APPLICATION NO.	FILING DATE	FIRST NAMED INVENTOR	ATTORNEY DOCKET NO.	CONFIRMATION NO.
10/629,873	07/30/2003	Shingo Johgan	4034-39	7357
23117	7590	05/04/2005		
NIXON & VANDERHYE, PC 1100 N GLEBE ROAD 8TH FLOOR ARLINGTON, VA 22201-4714				
			EXAMINER WANG, GEORGE Y	
			ART UNIT 2871	PAPER NUMBER

Office Action Summary

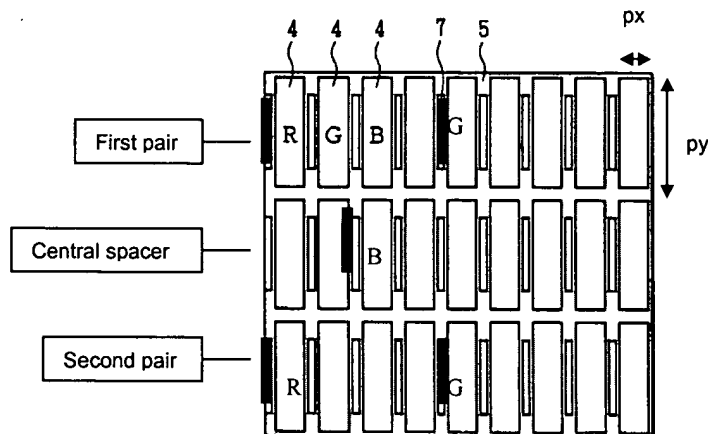
4. As to claim 1, Izumi discloses a color filter substrate comprising a base member (CF substrate, fig. 4, ref. 1), a color filter layer (fig. 5, ref. 4), which is provided on the base member and which is made up of a first, second, and third group of color filters each representing three different colors (fig. 5, ref. R, G, B), and a plurality of spacers (fig. 5, ref. 7), which are provided at predetermined relative positions for selected ones

of the color filters, such that the smallest number of color filters of the first, second, or third group is at least 80% of the largest number of color filters of the first, second, or third group (fig. 5).

6. As per claims 5-6, Izumi discloses the color filter substrate as recited above, where the color filters are arranged at a predetermined pitch, p_x , in a row direction and at another predetermined pitch, p_y , in a column direction, respectively, and where the spacers include a set of five spacers, the first pair being separated from each other by a distance of $m * p_x$ (where m is an integer equal to or greater than 2 by is not a multiple of 3) in a row direction, the second pair being separated from the spacers of the first pair by a distance of $n * p_y$ (where n is a positive integer and a multiple of 2) in the column direction, and the central spacer being separated from the spacers of the first pair by a distance of $m * p_x/2$ in the row direction and by a distance of $n * p_y/2$ in the column direction, respectively (see clarifying references included by Examiner in fig. 5 below), such that the first pair of spacers and the central spacer consist of a first spacer, a second spacer, and a third spacer associated with the first, second, and third groups of color, respectively, the second pair of spacers and the central spacer consist of

another first spacer, another second spacer, and another third spacer associated with the first, second and third groups of color filters, respectively (see clarifying references included by Examiner in fig. 5 below).
